Re: Docket No. 20190170-WS - Application for transfer of facilities Certificate Nos. 259-W and 199-S in Broward County from Royal Utility Company to Royal Waterworks, Inc. – Response to Staff Deficiency Letter

Royal Utility Company
PWSID: 4061517
June 20, 2017

RE: 2017 Sanitary Survey - Royal Utility Co.

Figure 4. Corrosion and leak observed at the flush-line cap for well#1.

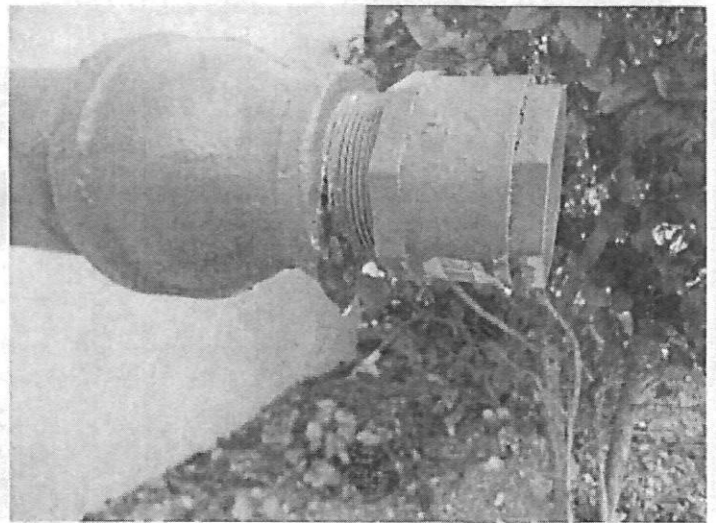
| Areas of Concern | Rule | Corrective Action | Date Corrected | Significant Deficiency? |
|---|--|--|----------------------------|-------------------------|
| Leak observed at flush-line for well pump #1. | 62-555.350(2) | Repair or replace. | | No (minor) |

3. Leak observed at flush-line for well pump #1. The leak has been repaired, Exhibit A Figure 3 shows repaired corrosion and Figure 4 a repaired leak.
4. Inadequate cross connection control program records. The above reference Cross Connection Control Plan will be developed as per FAC 62-555.360(2) and will include inventory records, inspection/testing and all other requirements.

Figure 9. Corrosion on manifold pipe leading to Accelerator.

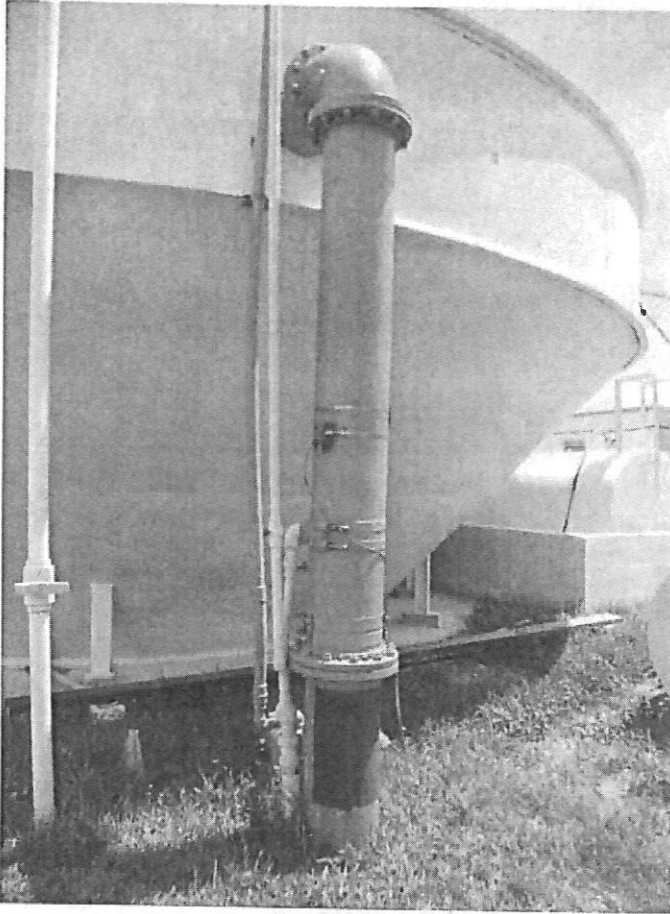
| Areas of Concern | Rule | Corrective Action | Date Corrected | Significant Deficiency? |
|---|--|--|----------------------------|-------------------------|
| Several plant components are corroded. | 62-555.350(2) | Refurbish or contact the Department if replacement is necessary. | | No (minor) |

4061517 FLOW DIAGRAM

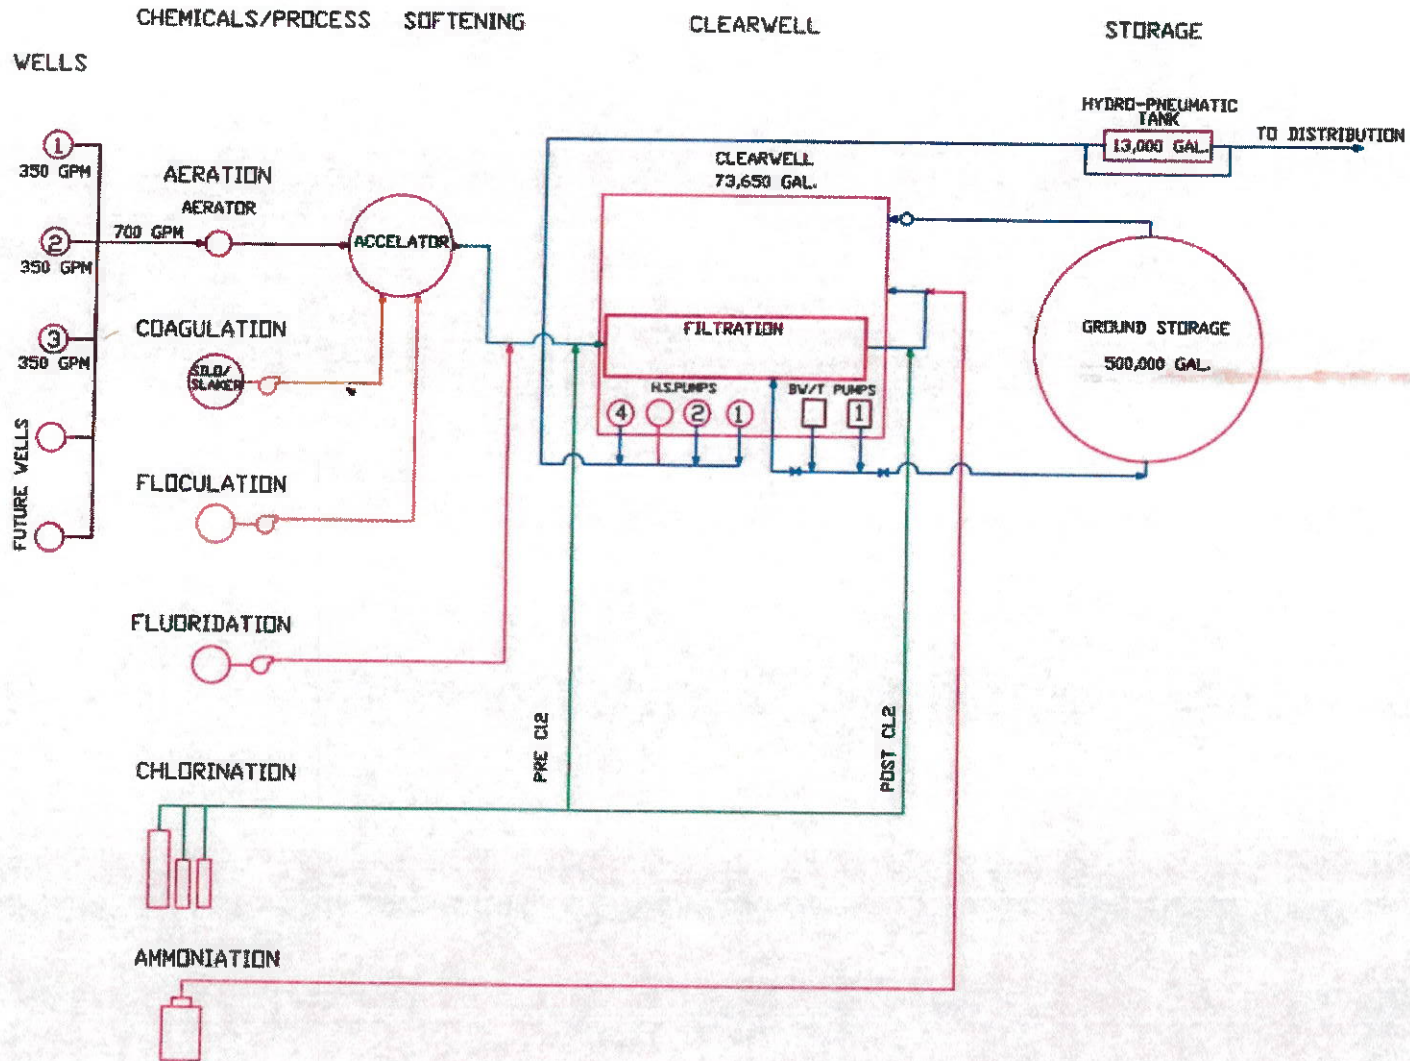
1. Provide Department with the number of inline valves contained in the distribution system.
2. Provide *rated pressure capacity* for each well pump and the *observed yield and pressure* for each well pump.
3. Provide the *On/off pressure settings* for each tank if applicable.
4. Provide an updated system diagram.

1. Provide Department with number of inline valves contained in the distribution system. A schematic (Exhibit B) of the water distribution system is provided which also shows the location of water distribution valves.
2. Provide *rated pressure capacity* for each well pump and the *observed yield and pressure* for each well pump. Provided in Exhibit C.
3. Provide on/off pressures for each tank. Hydro-pneumatic tank on at 60 psi and off at 85 psi. Clearwell altitude valve from ground storage tank, on at 30 inches, off at 65 inches.
4. Provide an updated system diagram. A process flow diagram of the water treatment system is included as Exhibit D.
